Re: Greenway Environmental Services, LLC  
Green Meadow Sustainable Solutions Landfill  
Solid Waste Application Deficiency  
Jefferson County, Mississippi  
Permit No. SW0320040549

On behalf of Greenway Environmental Services, LLC (Greenway), Allen Engineering and Science, Inc. (AllenES) is submitting this letter to address application comments and concerns previously made by the MDEQ in a letter dated October 2, 2025 regarding the December 15, 2024 Revision 0 Permit Application Report (PAR). Listed below are the comments (previously made) along with a response.

**FIGURE  
1**

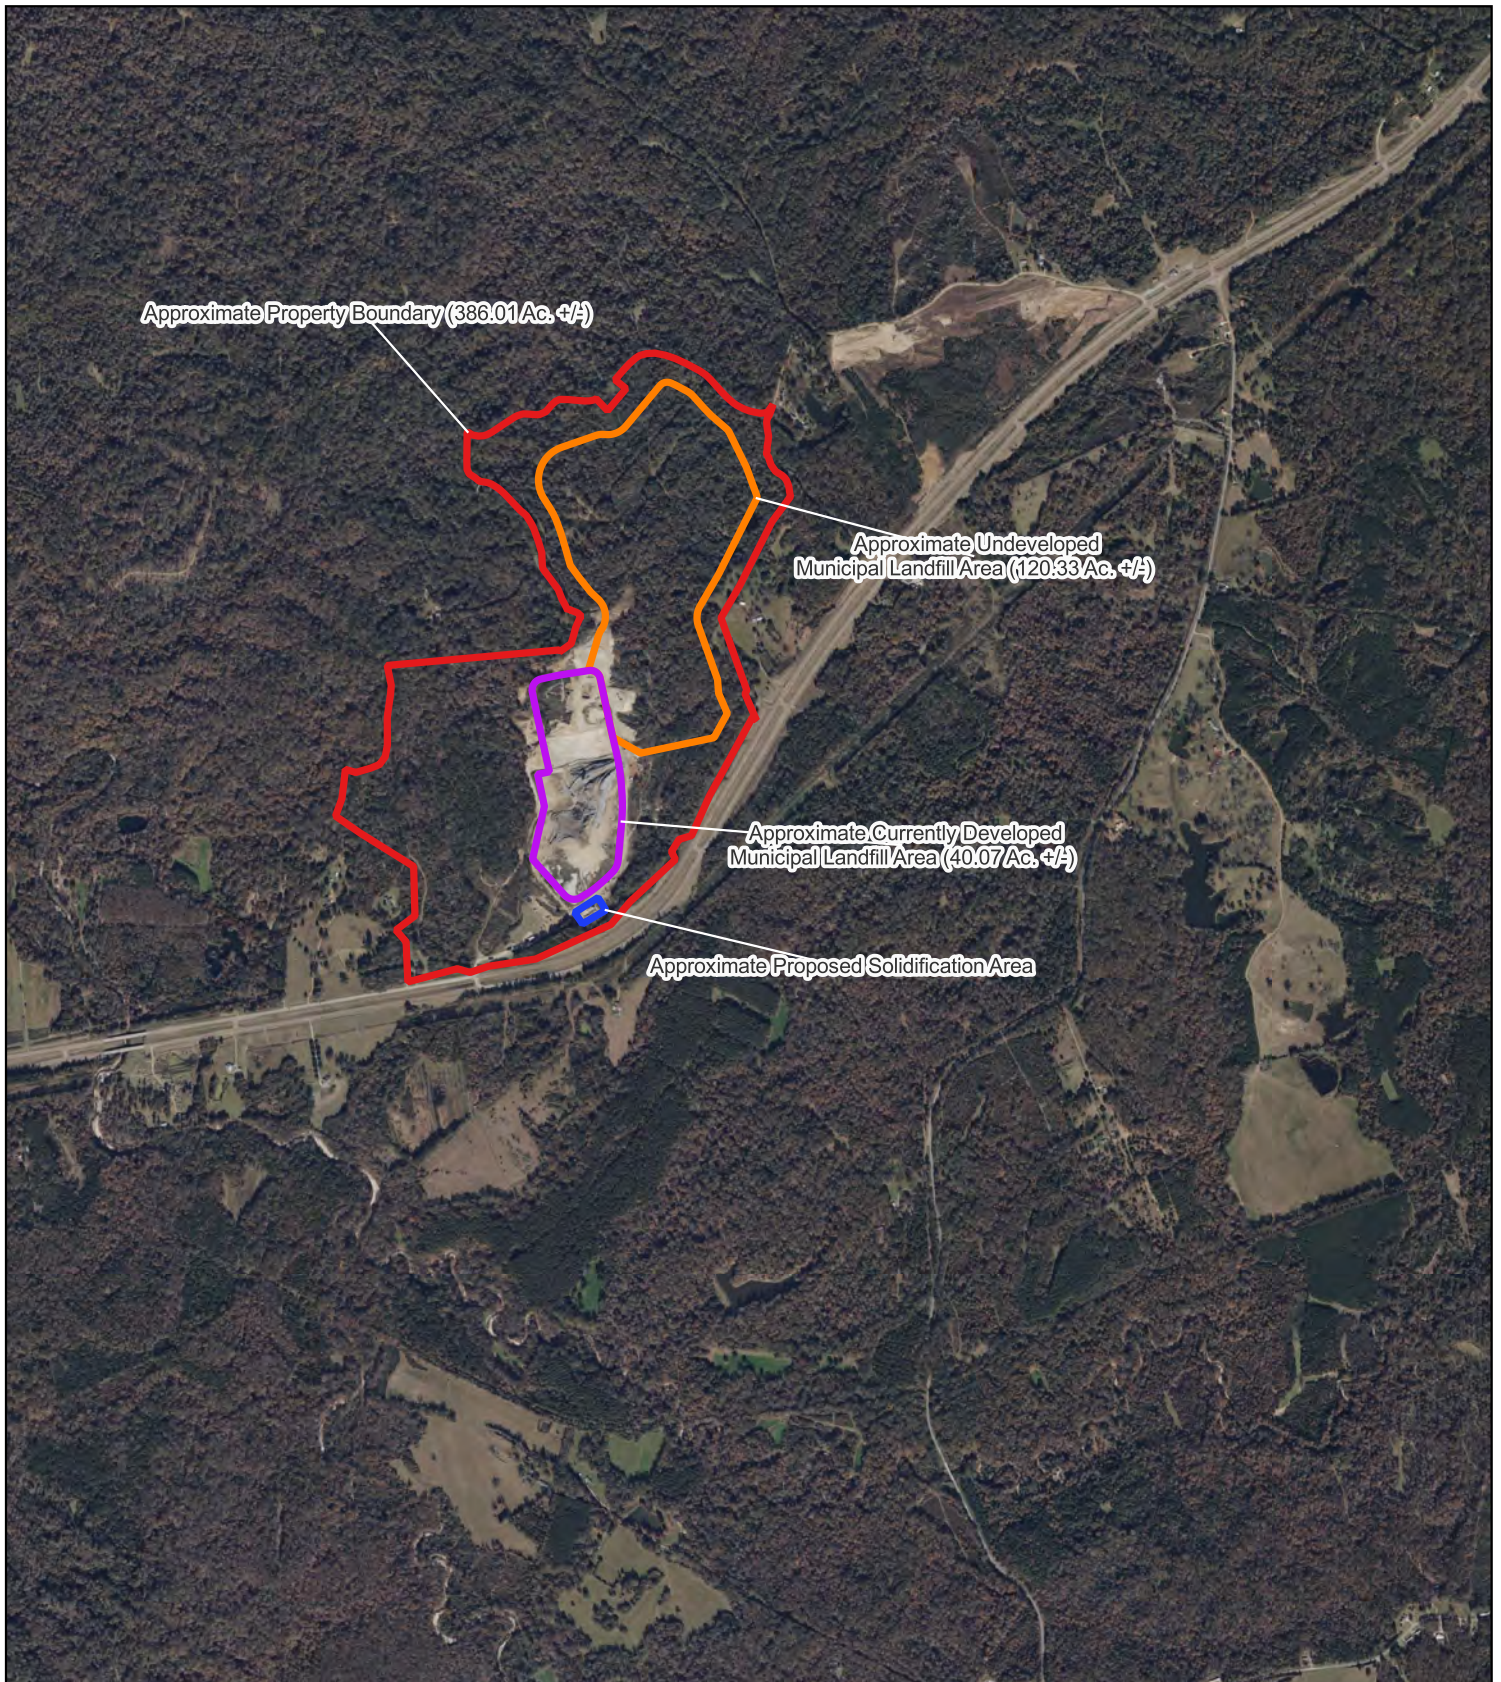
**2. Sections 5.8 and 5.9.3, Waste Solidification Plan (Appendix K) – Three referenced figures (Figures 1, 2, and 3) are missing from the Waste Solidification Plan. Please provide the missing figures.**

AllenES has provided the three missing figures in **Appendix K** of the PAR Revision 01 at the end of the Solidification Plan document.

| 16B           | 1                     |

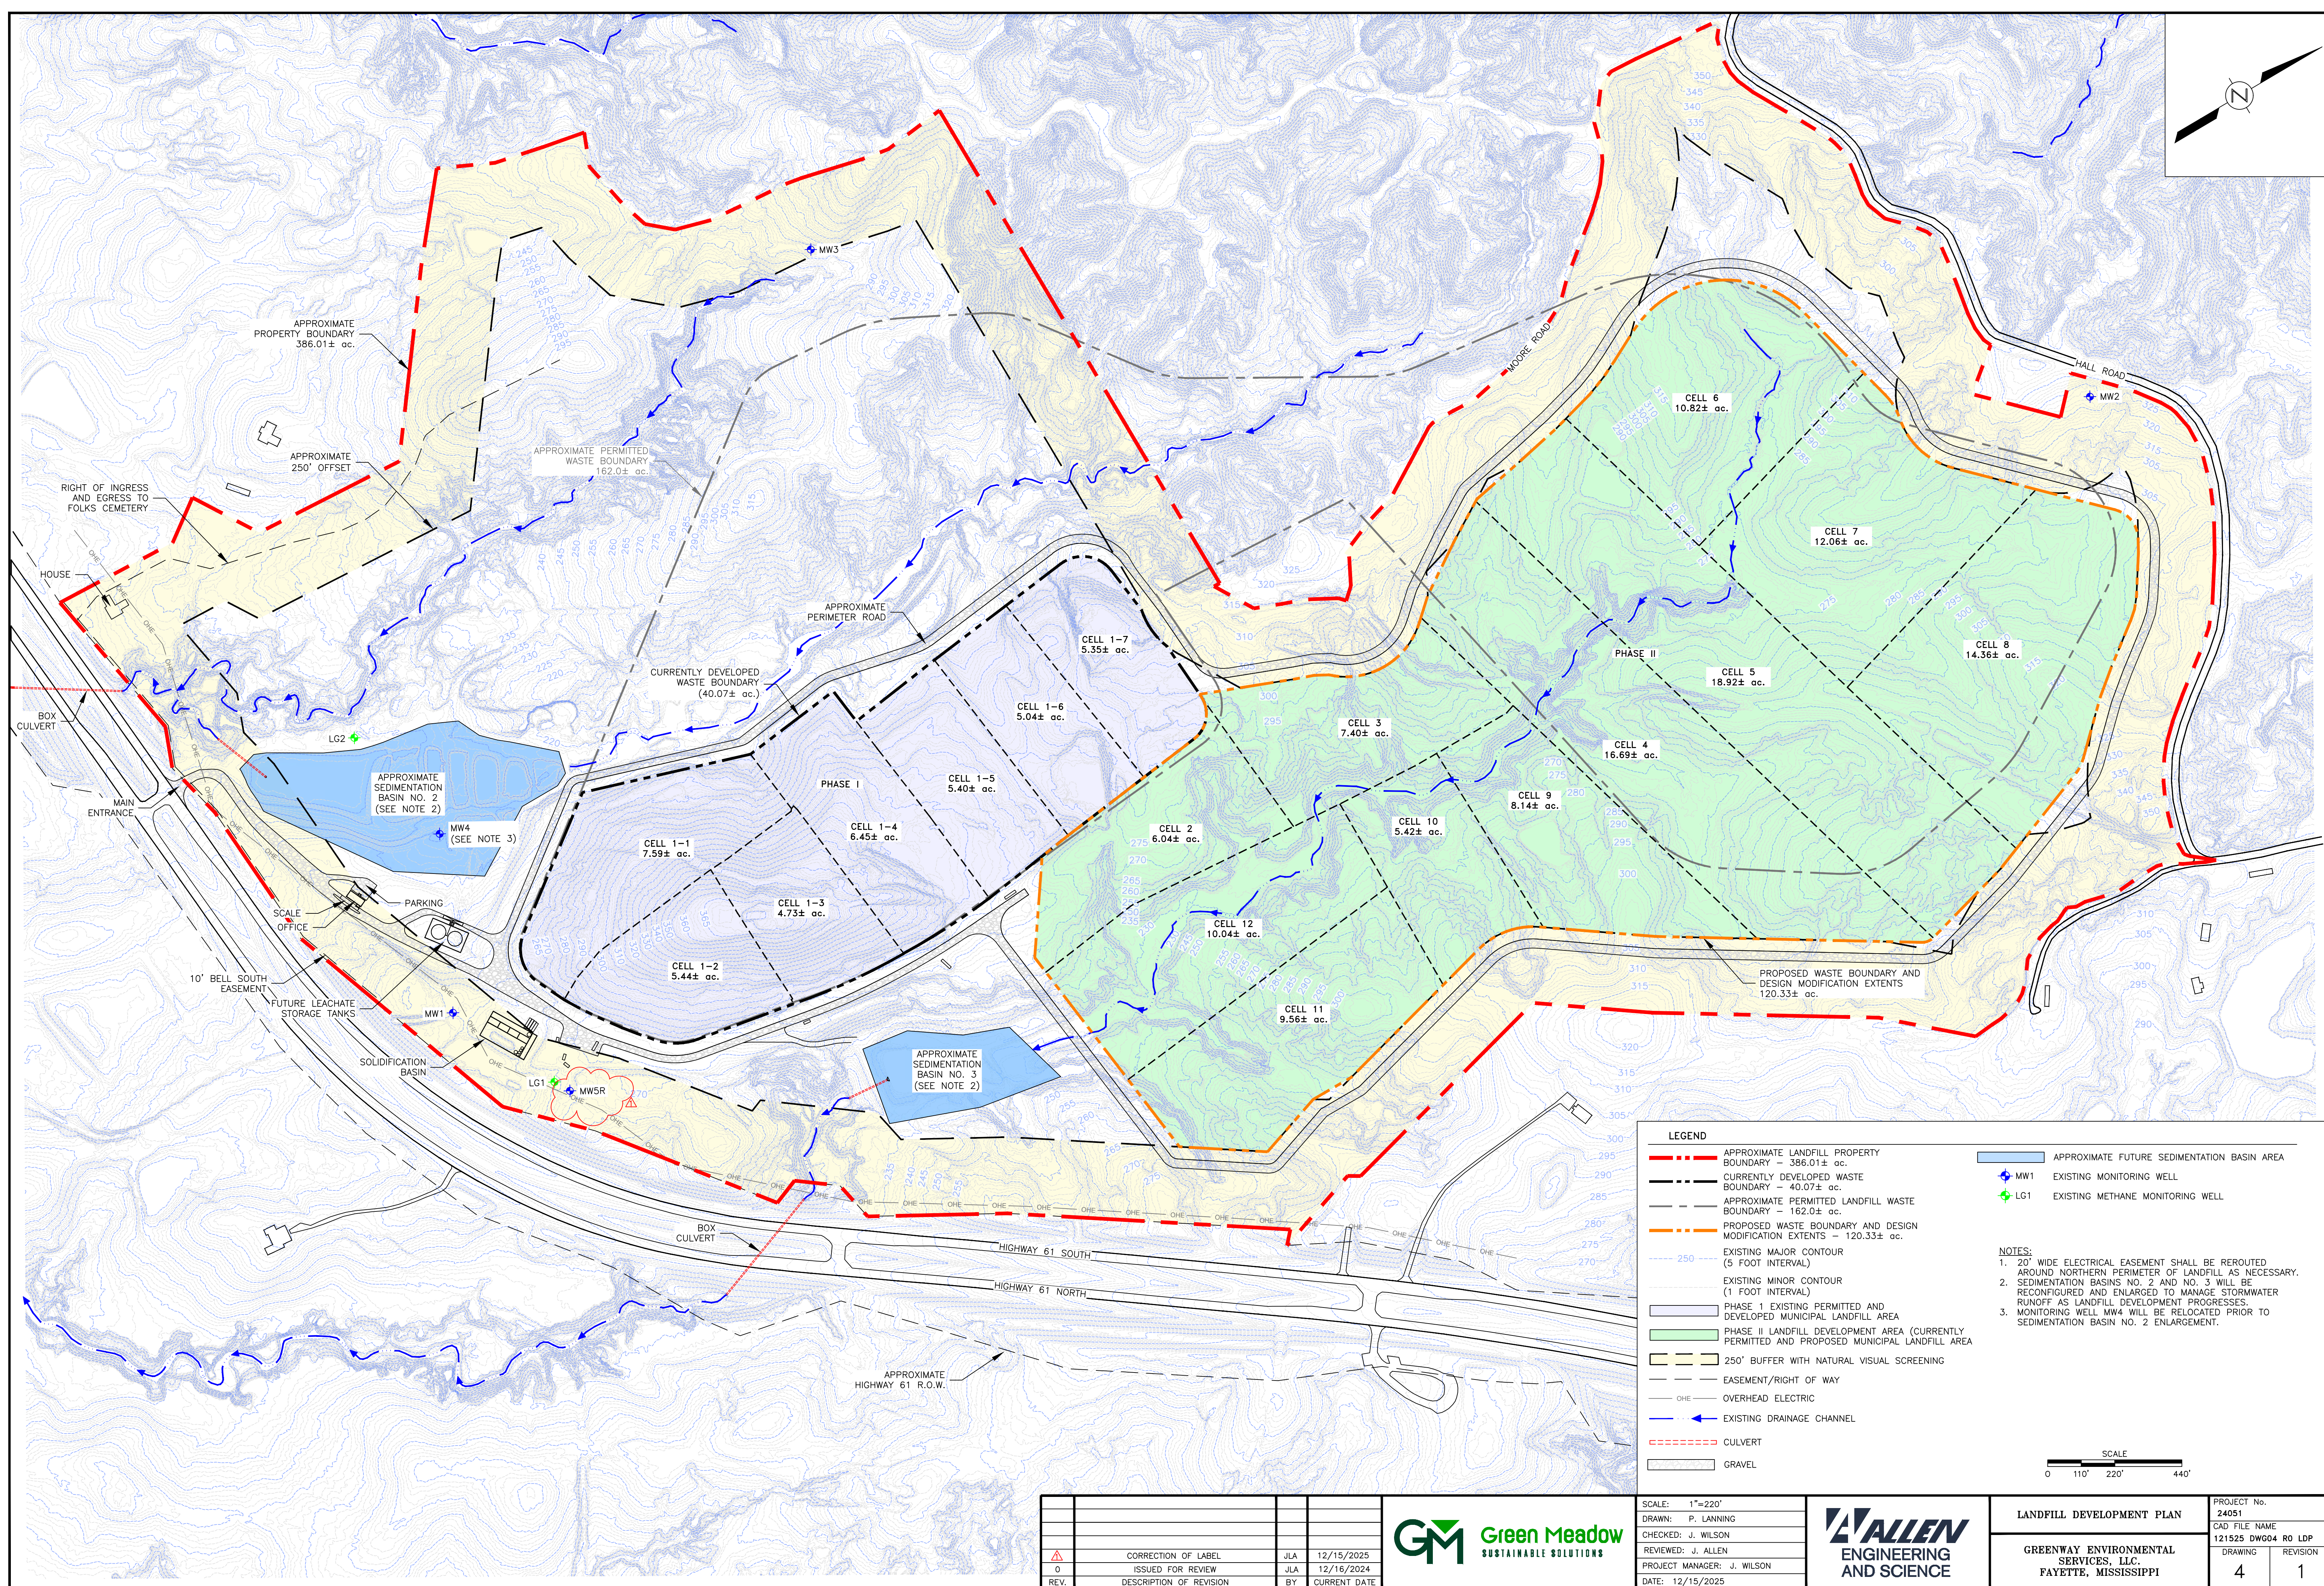
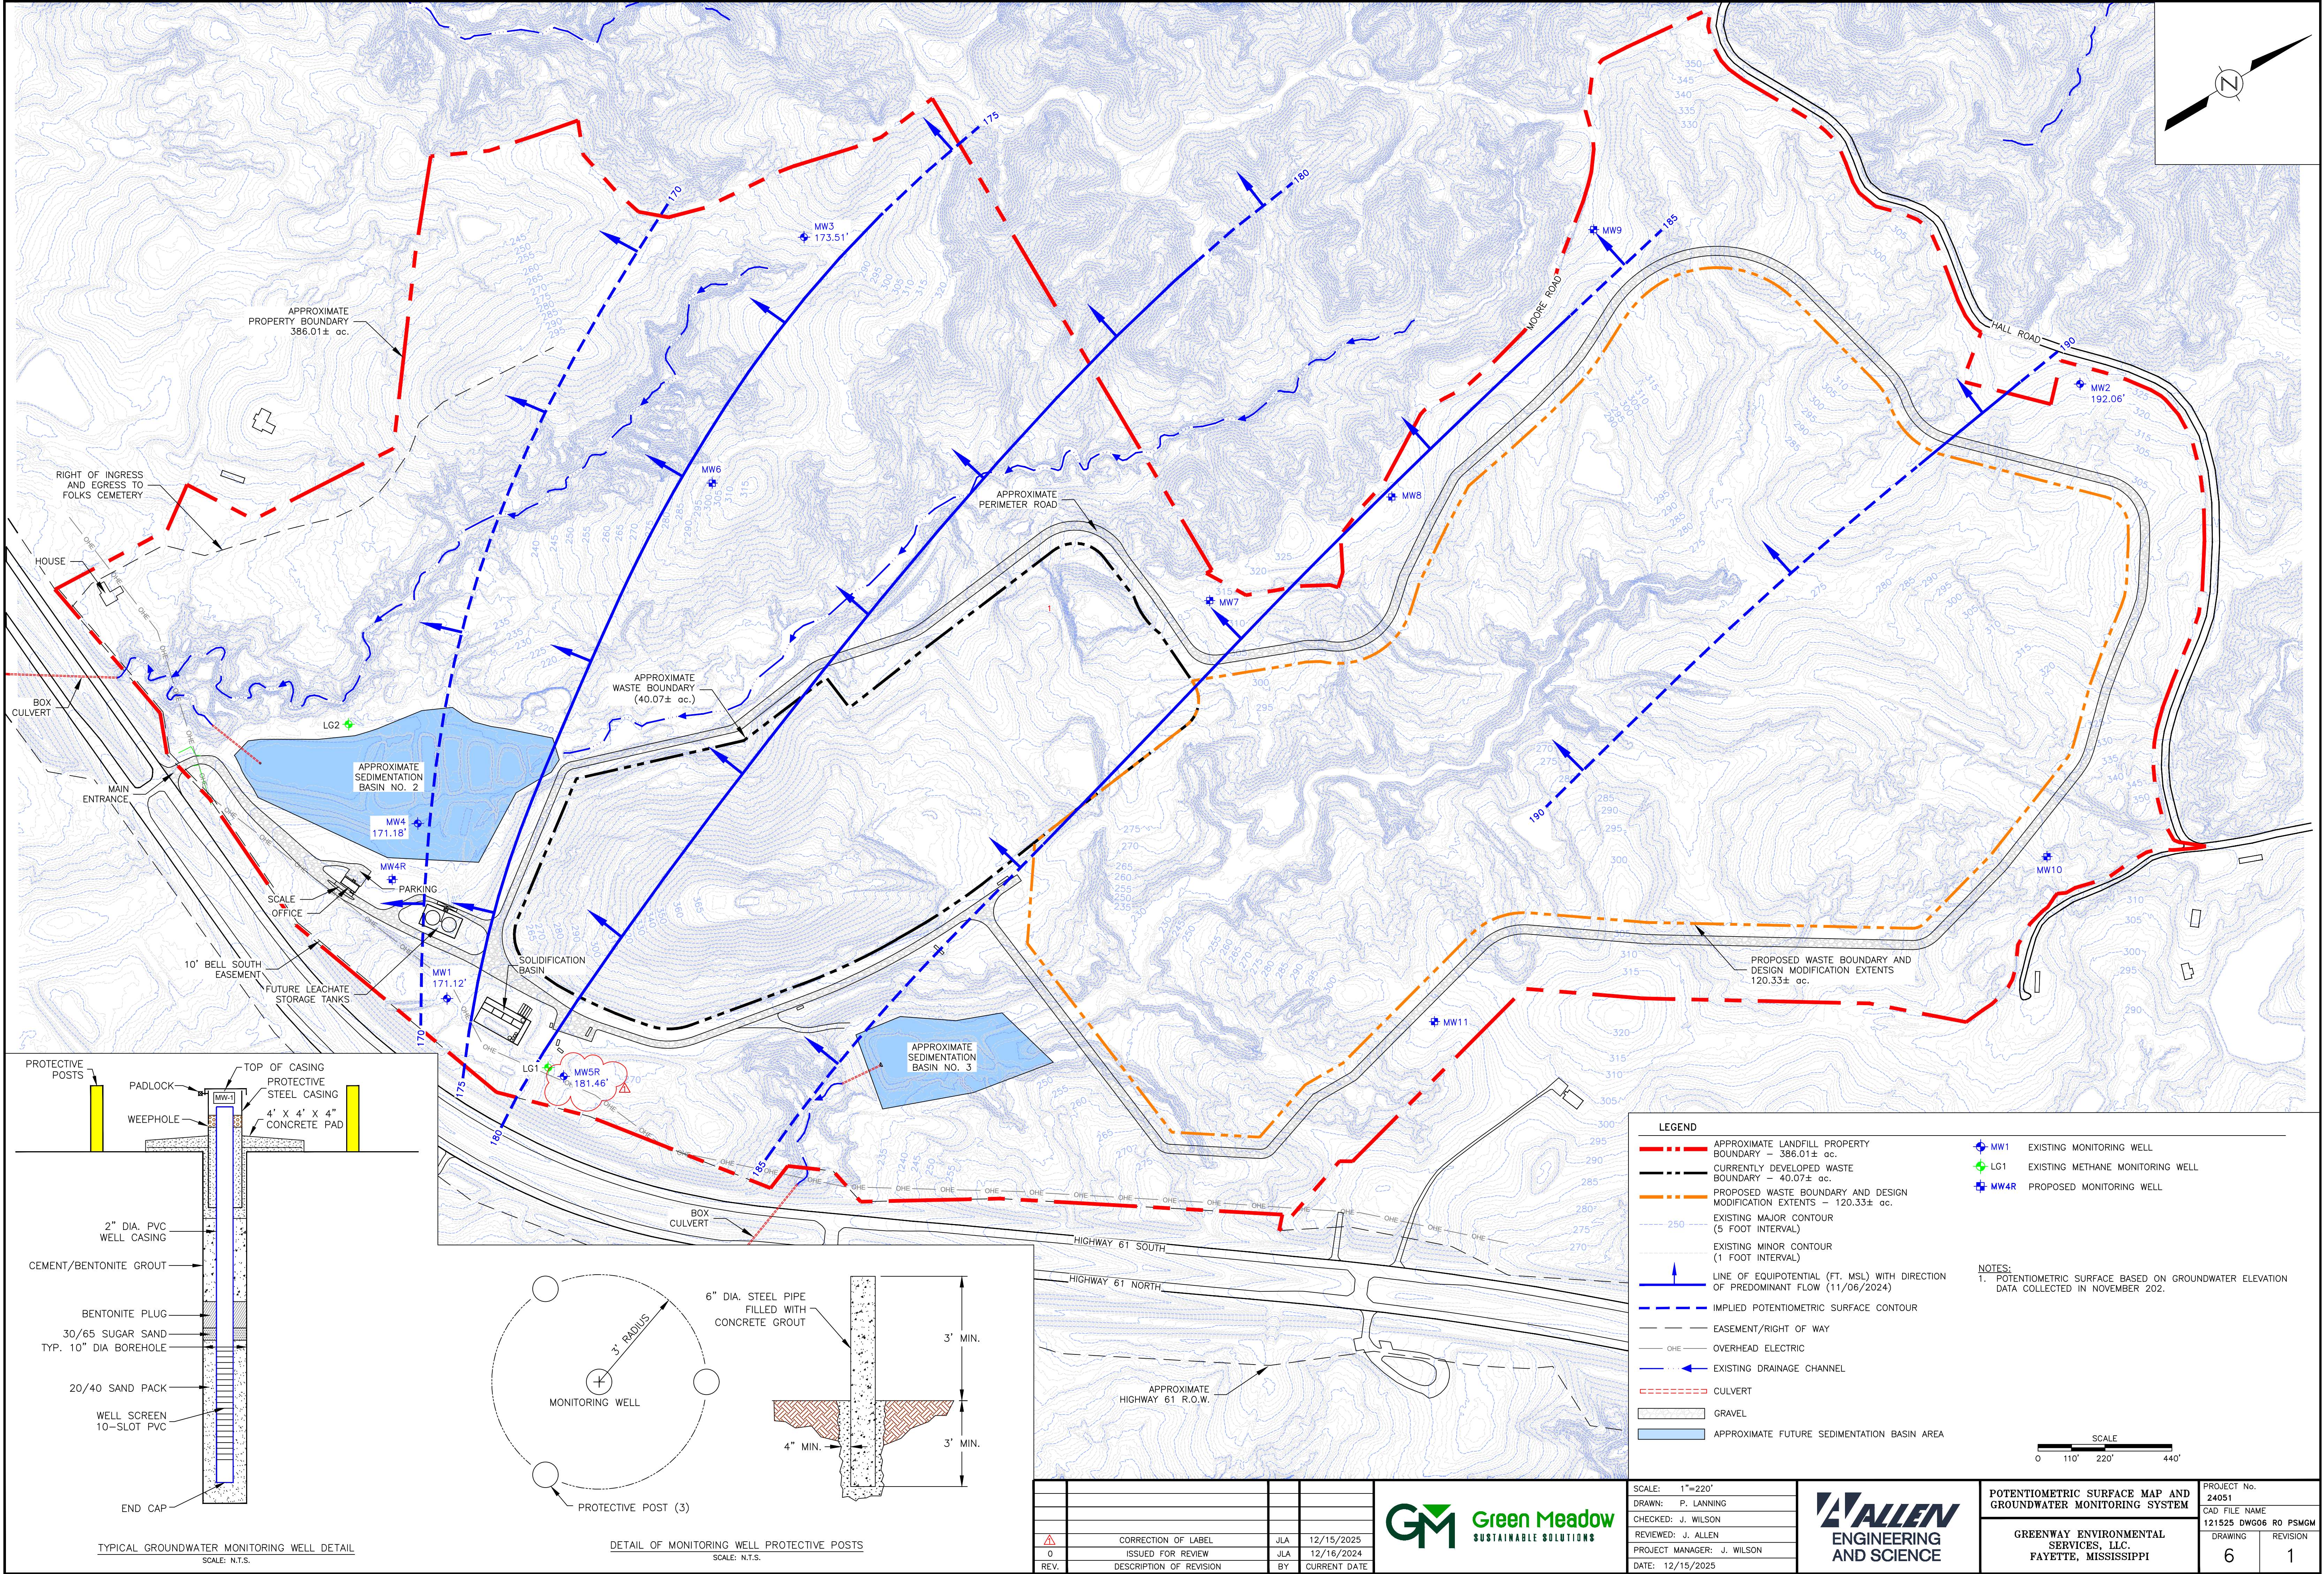
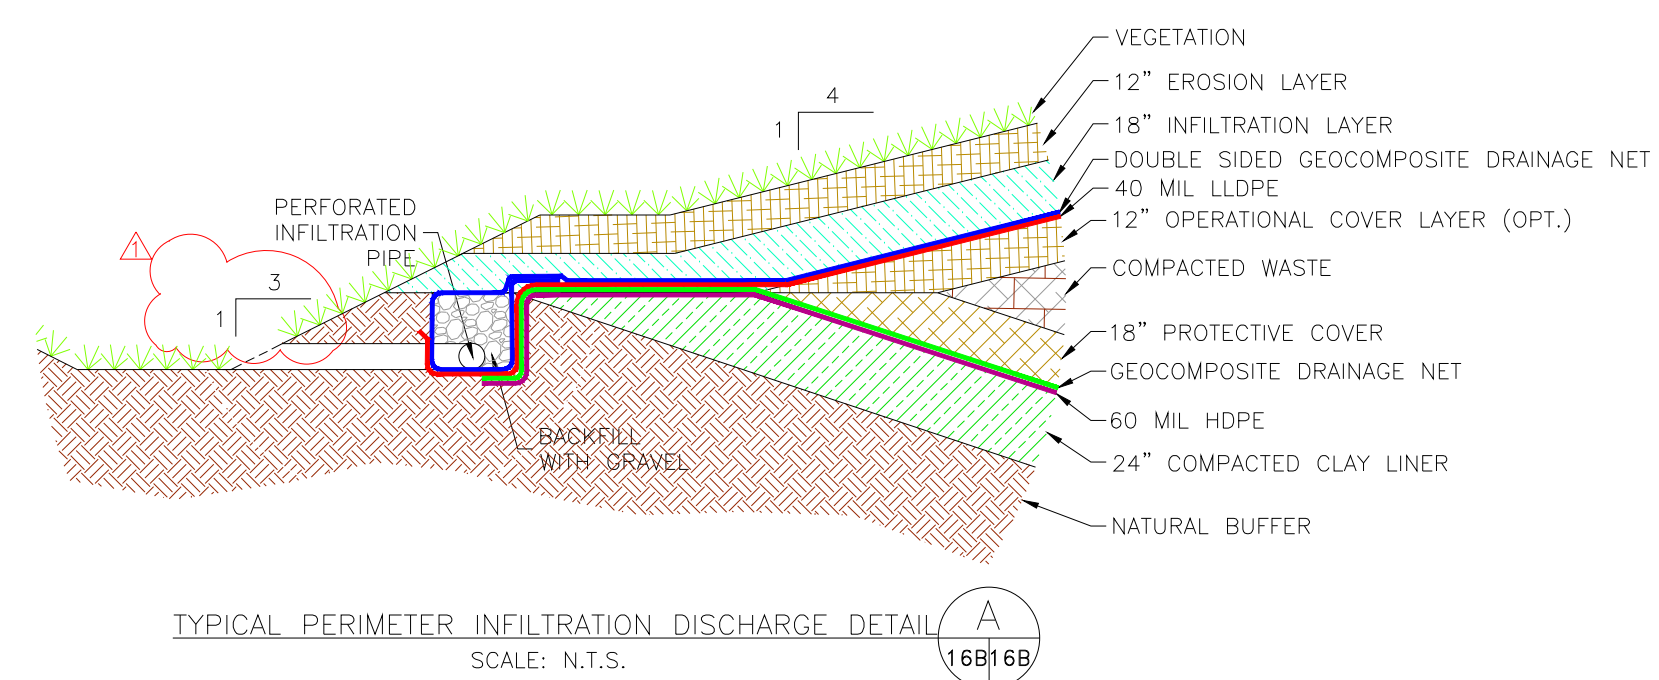
**14. Drawing 16B – External side slopes do not coincide in the referenced sections. Please revise.**

AllenES has updated Drawing 16B to address the Department's comment. The revised Drawing 16B has been included in **Appendix L**.
